UTILITY PLAN

CITY OF MADISON, WISCONSIN

6502 Milwaukee St and 6501 Town Center Dr
Contract No. 8403
Project No. 12323
Addendum No. 1

C - 1.8

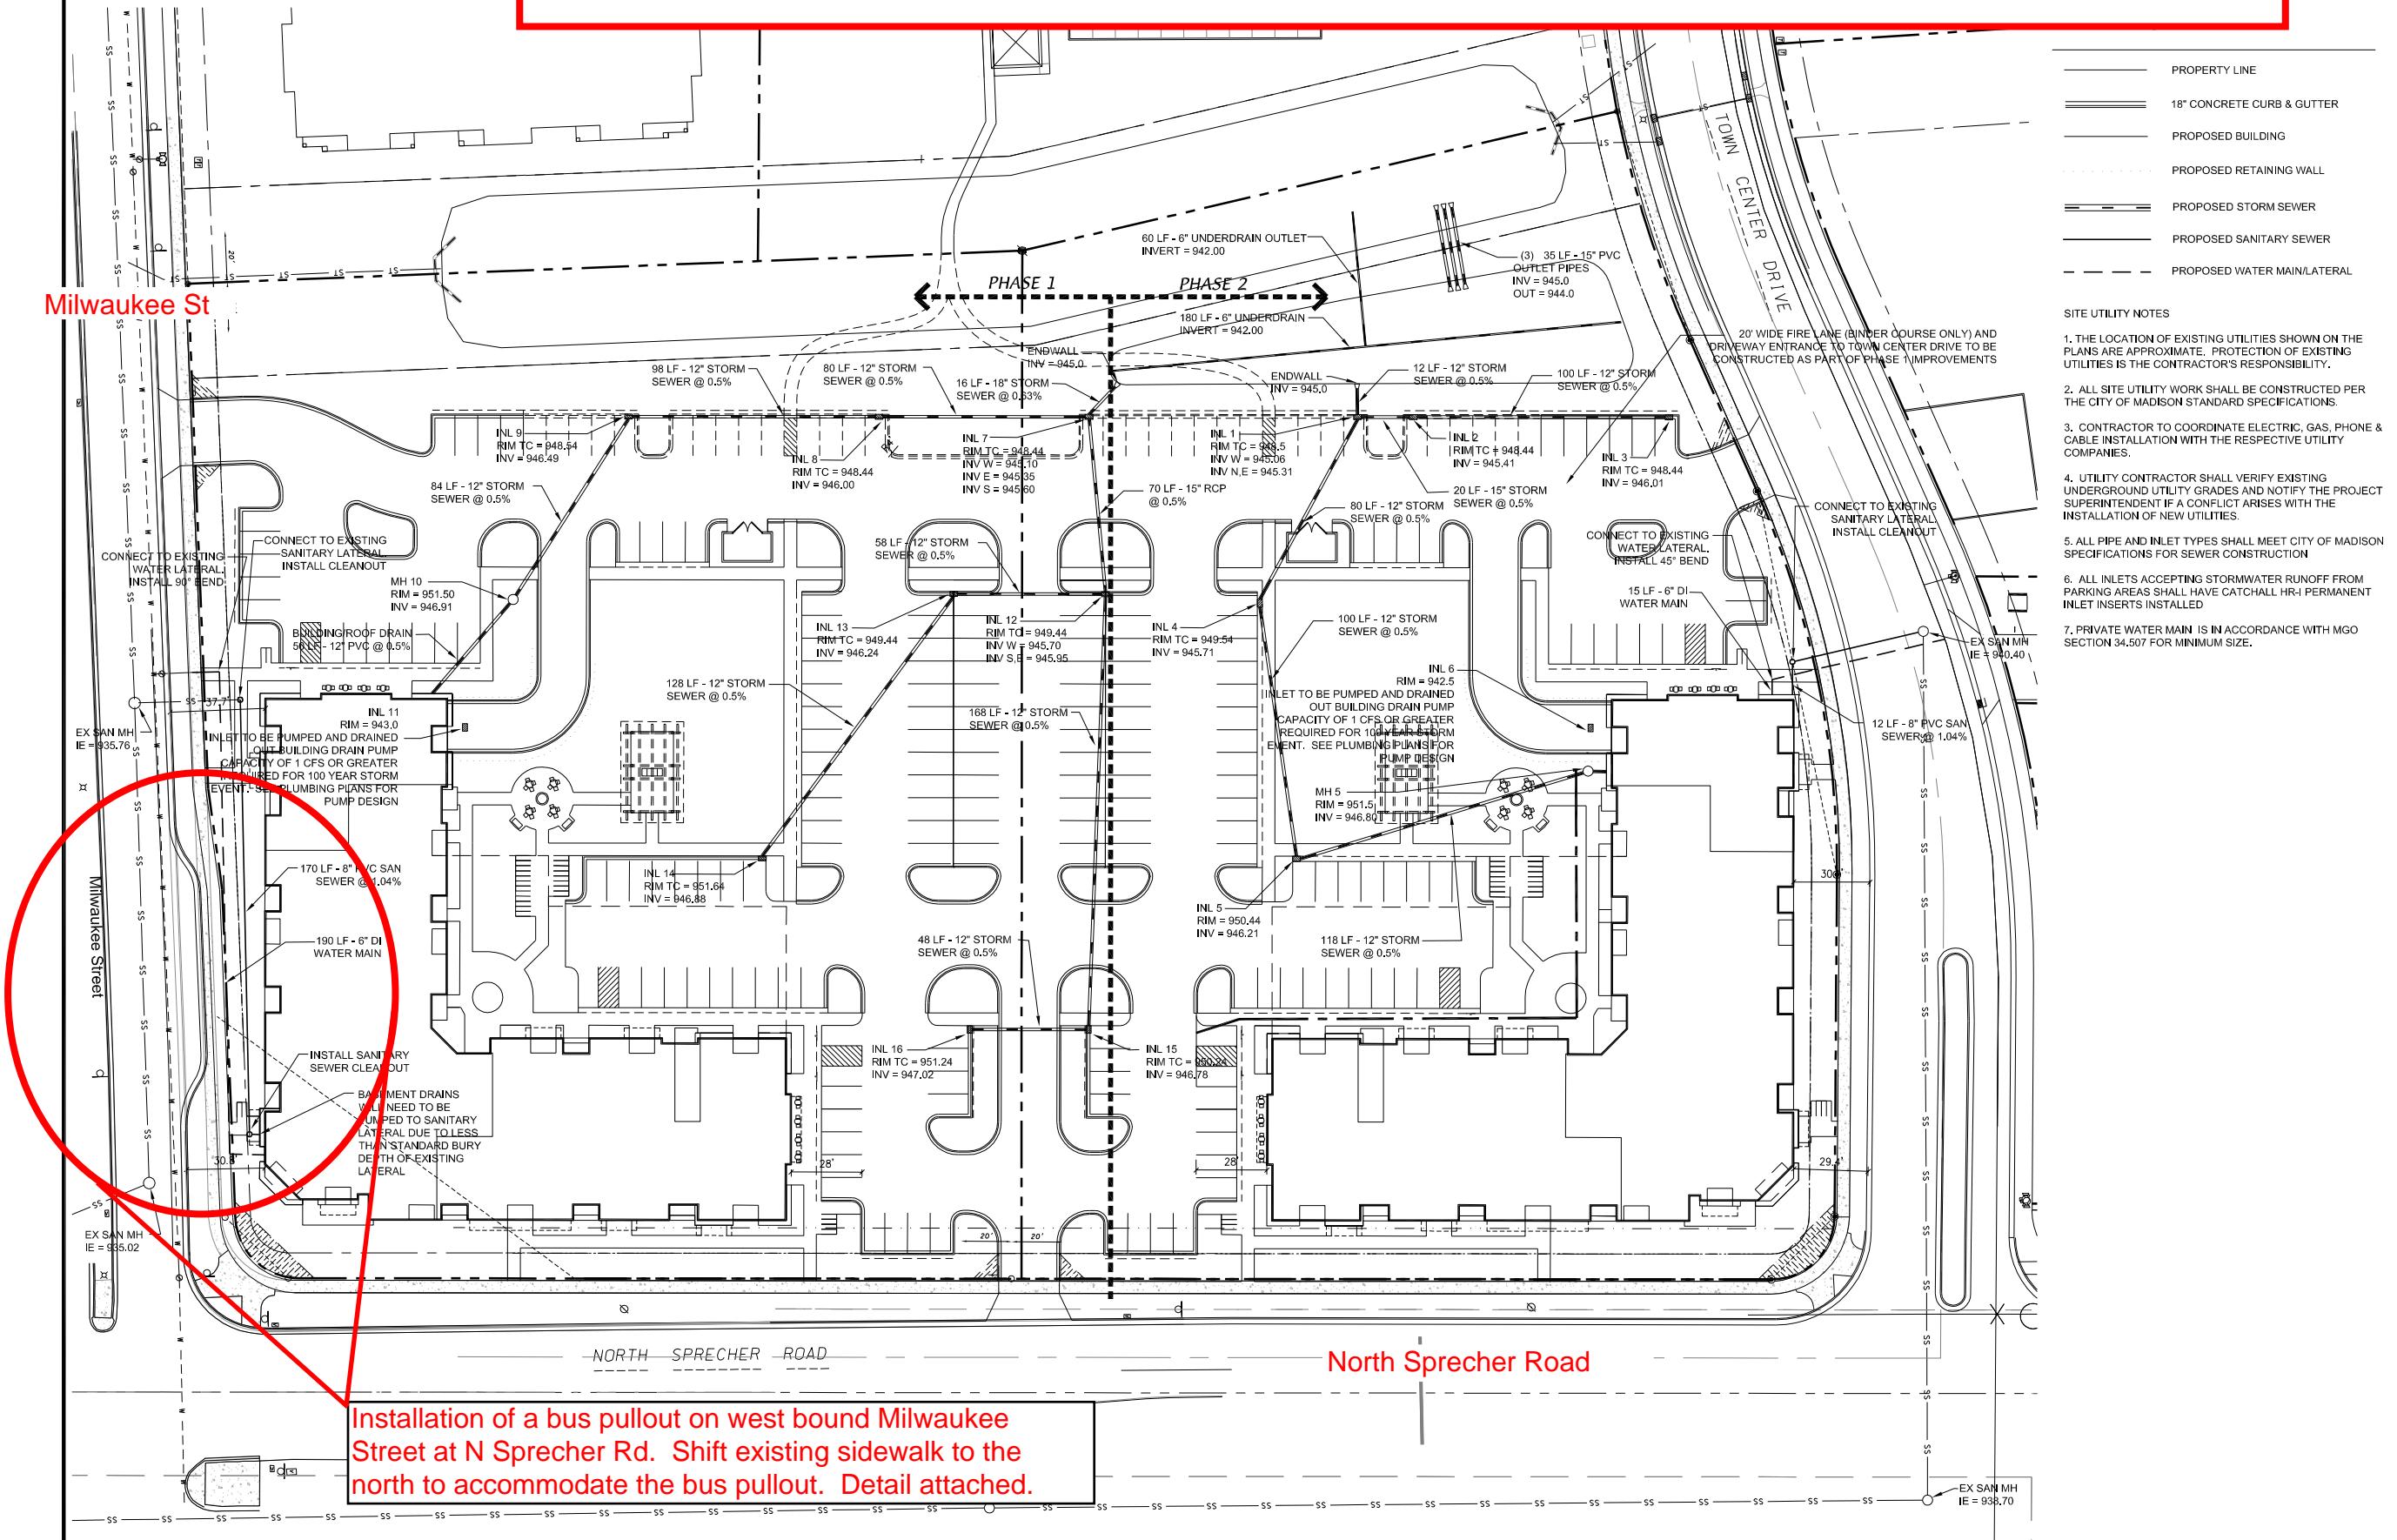
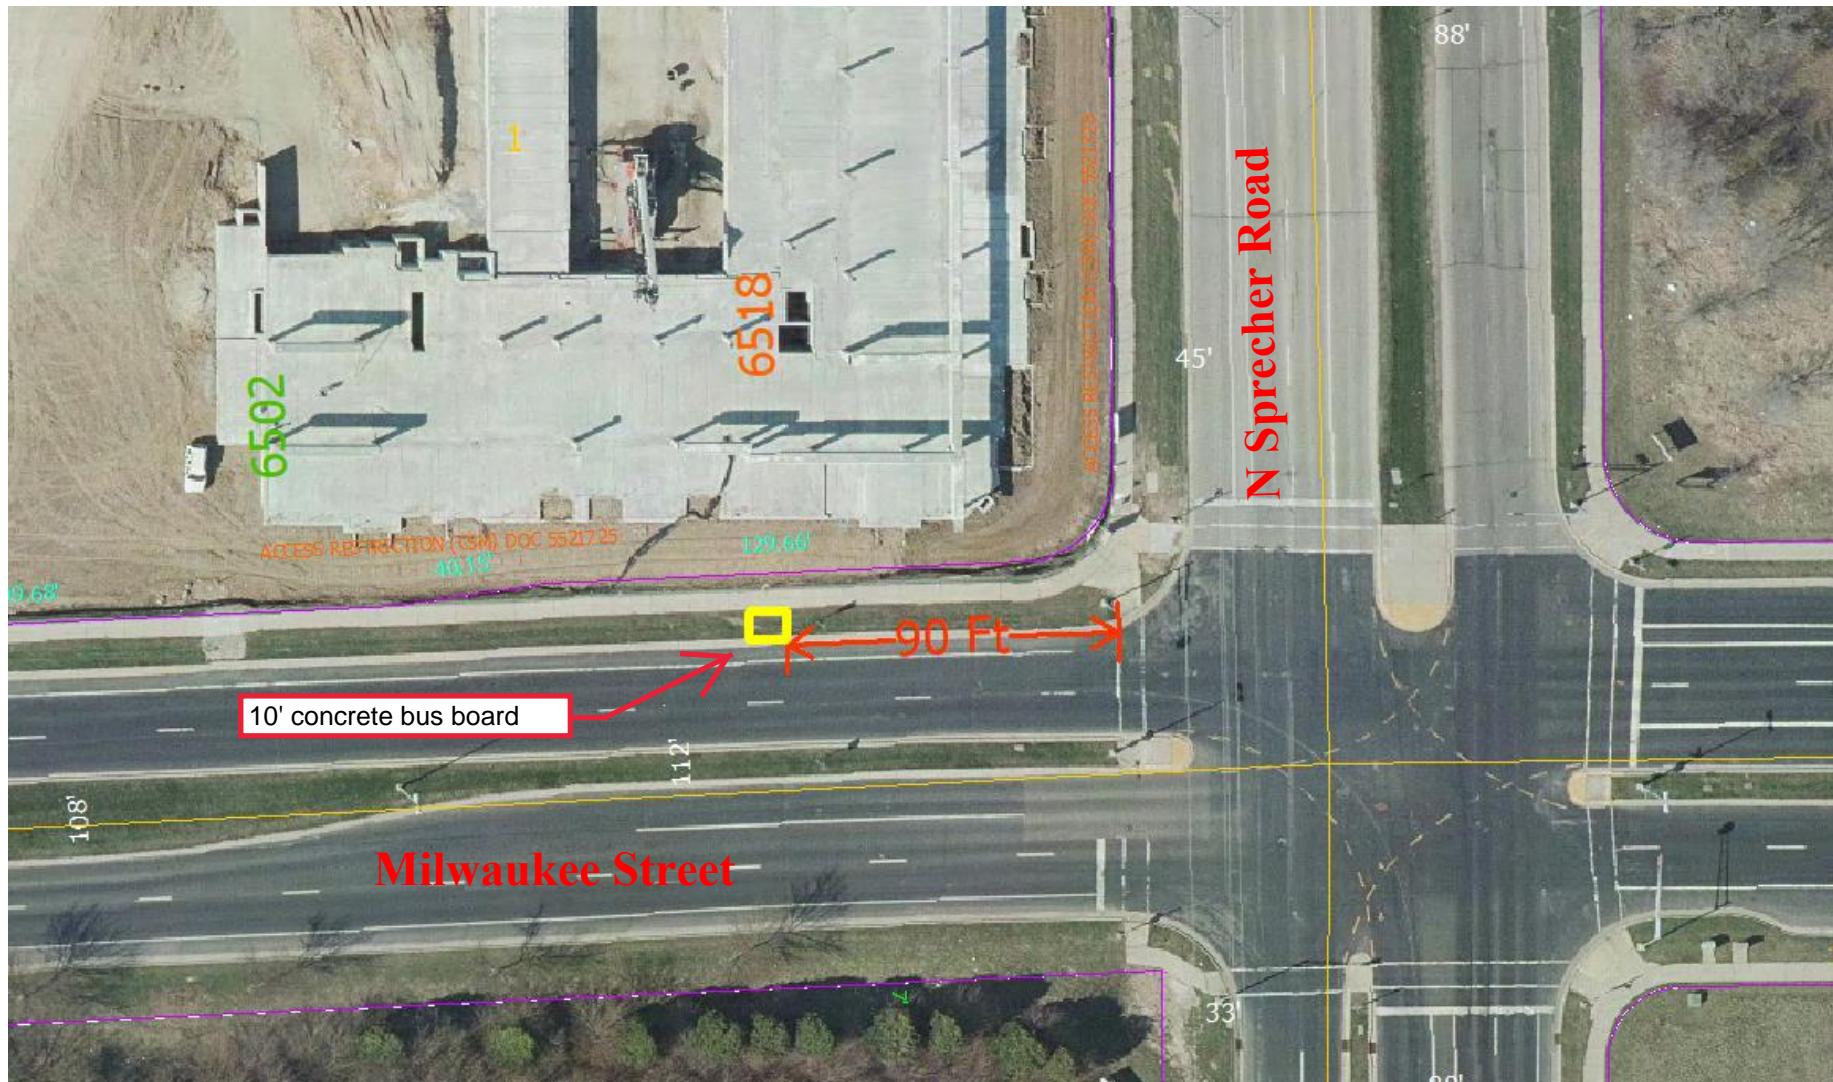
Represents original plans approved. Bus pull out will be eliminated and standard bus in-lane stop with 10' concrete boarding pad will be constructed by developer with Addendum No. 1.

Installation of a bus pullout on west bound Milwaukee Street at N Sprecher Rd. Shift existing sidewalk to the north to accommodate the bus pullout. Detail attached.

Addendum No. 1: remove the proposed bus pullout on the north side of Milwaukee Street west of Sprecher Road from the plans and replace it with an in-lane stop and ten-foot concrete boarding pad surface
